ENGINE - LP TURBINE MODULE AND EXHAUST GAS TEMPERATURE (EGT) INDICATING SYSTEM -
PROVIDE RECONTOURED EGT BRACKETS AND DOUBLE HEXAGONAL HEADED NUTS - CATEGORY CODE 5 -
MOD.ENG-72-0050

V2500-ENG-72-0050

Replacement of loop clamp brackets and attaching nuts
Fig.1 (Sheet 1 of 2)

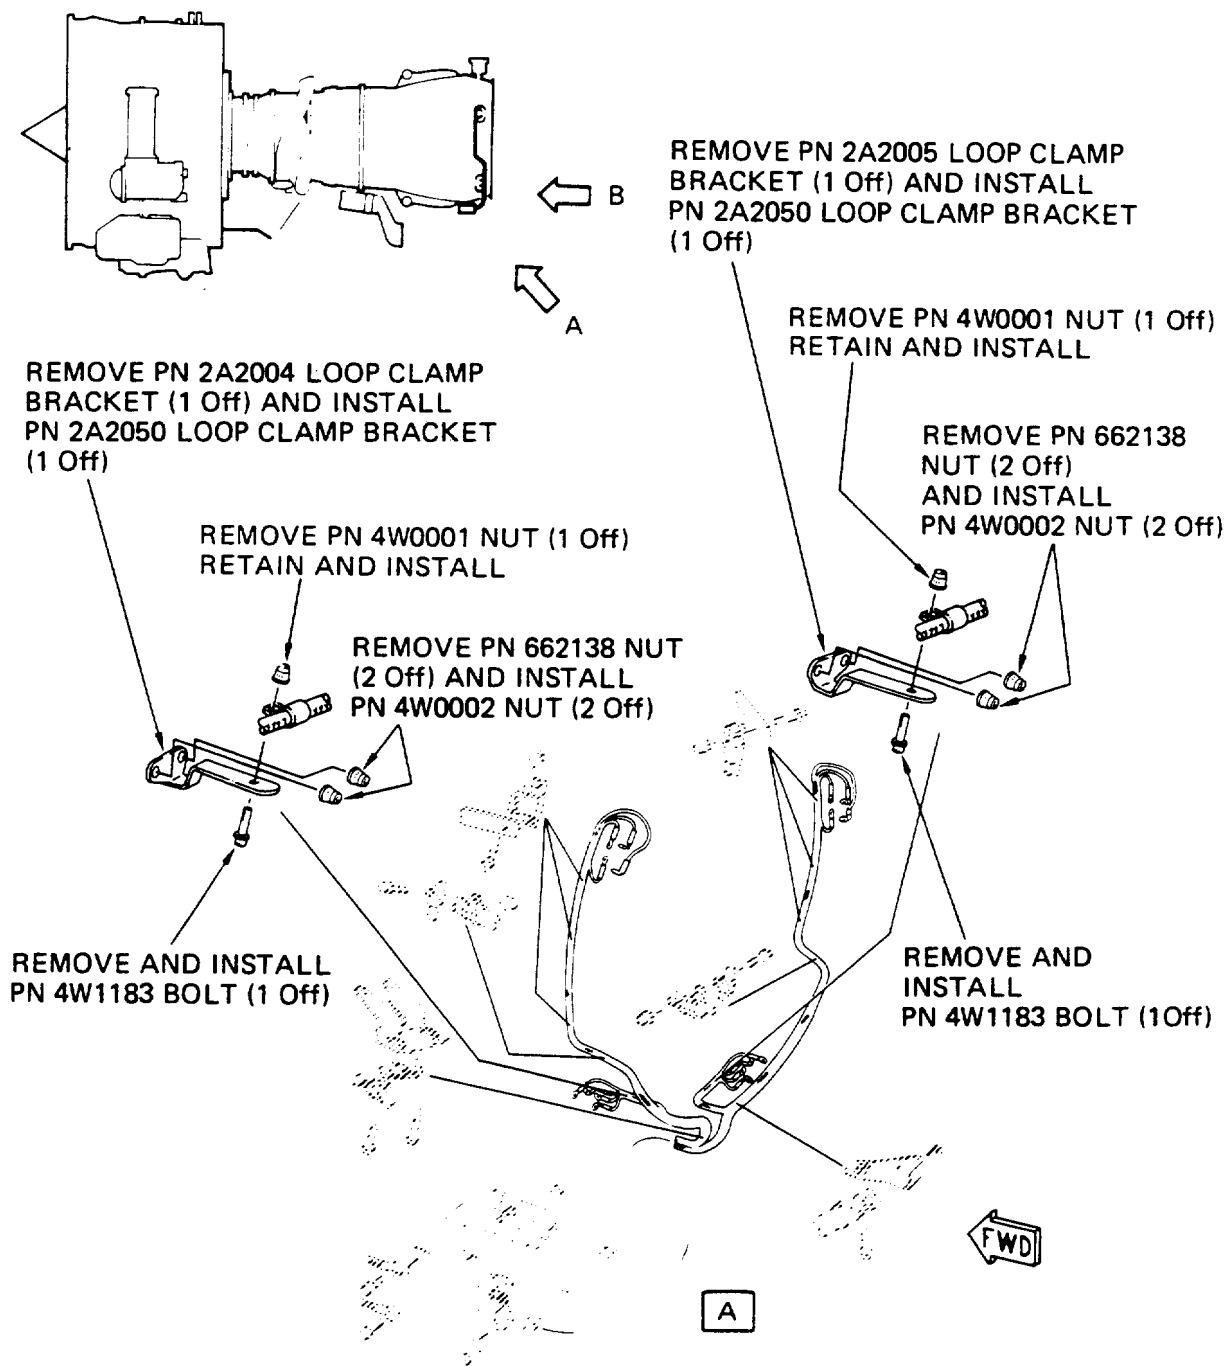
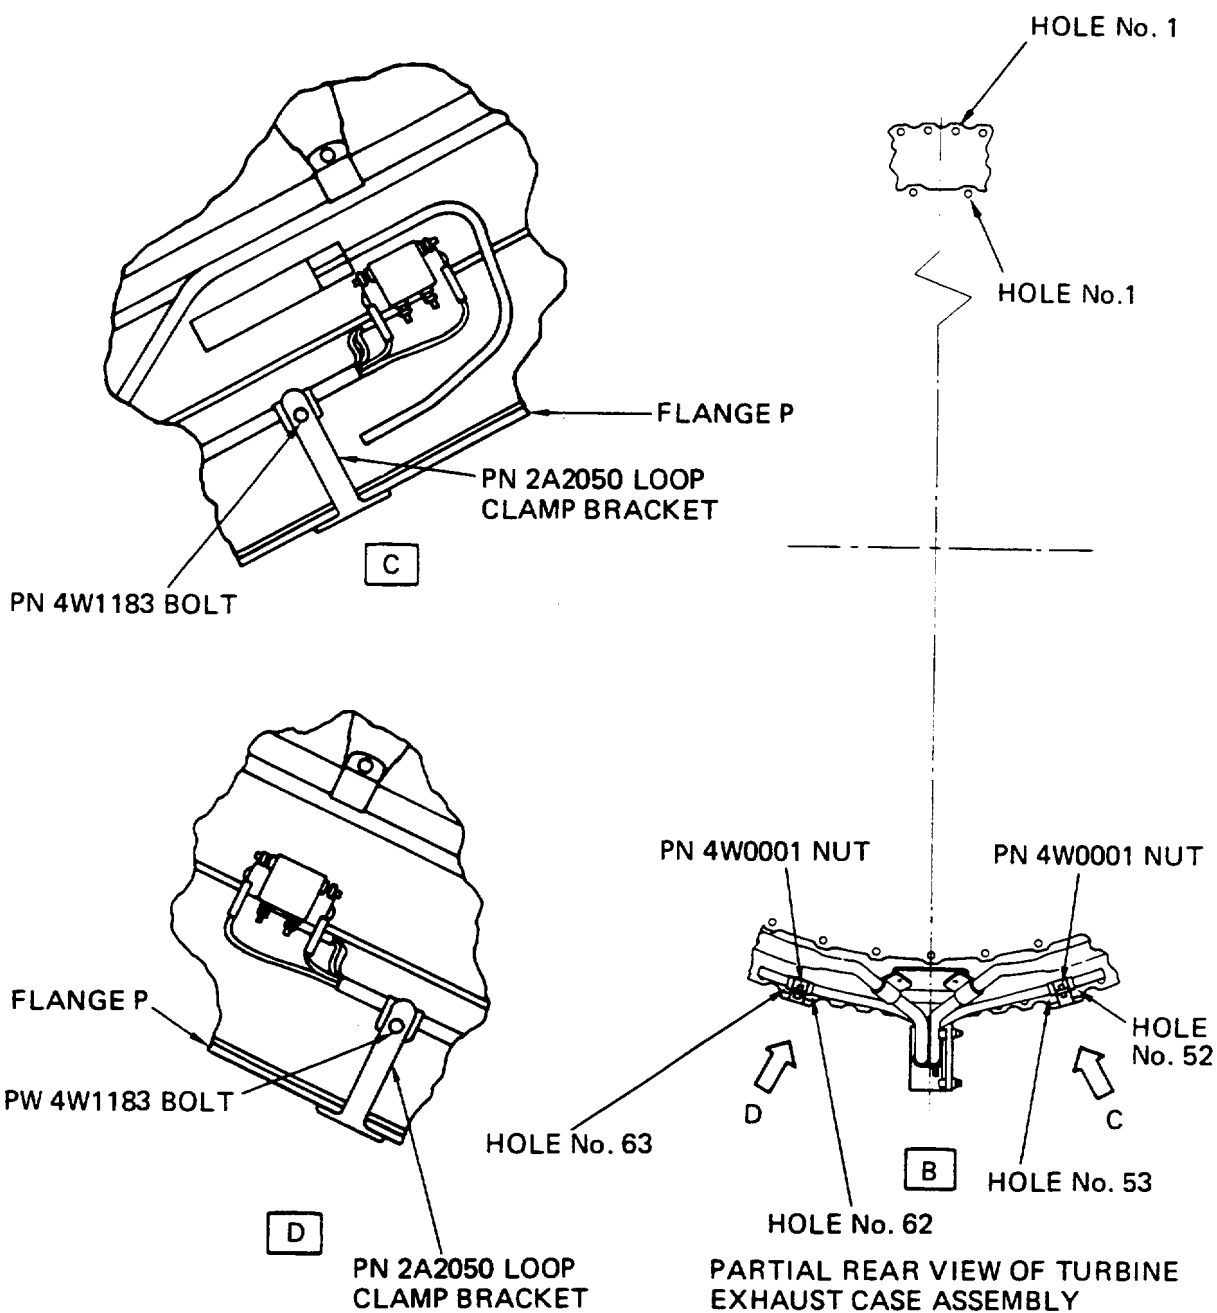
The present configuration EGT Brackets on Flange P at hole location 52, 53, 62 and 63 has contact with the Hold-Open Rod Brackets for the C-Ducts.

- (1) Interference between the EGT Brackets (at Flange P hole locations 52, 53, 62 and 63) and Hold Open Rod Brackets for the C-Ducts is removed as follows:
- (a) Two new brackets are provided to attach the Harness at the locations specified.
 - (b) New Nuts are provided to attach the Loop Clamp Brackets to the Flange P.

- (5) Put the 2A2050 Loop Clamp Bracket (1 off) at the location of holes 62 and 63. Refer to Figure 1.
 - (a) Make sure that the bracket mount flange is forward of Flange P.

- (6) Install the Nuts and Bolts and tighten them with your hand.
- (7) Put the 2A2050 Loop Clamp Bracket (1 off) at the location of holes 52 and 53. Refer to Figure 1.

- (a) Make sure that the bracket mount flange is forward of flange P.
- (8) Install the Nuts and Bolts and tighten them with your hand.
- (9) Torque the Bolts to between 85 to 105 lbfin (9,60 to 11,86 Nm). See Reference (2) Chapter/Section 70-41-00, Torque Tightening Technique.
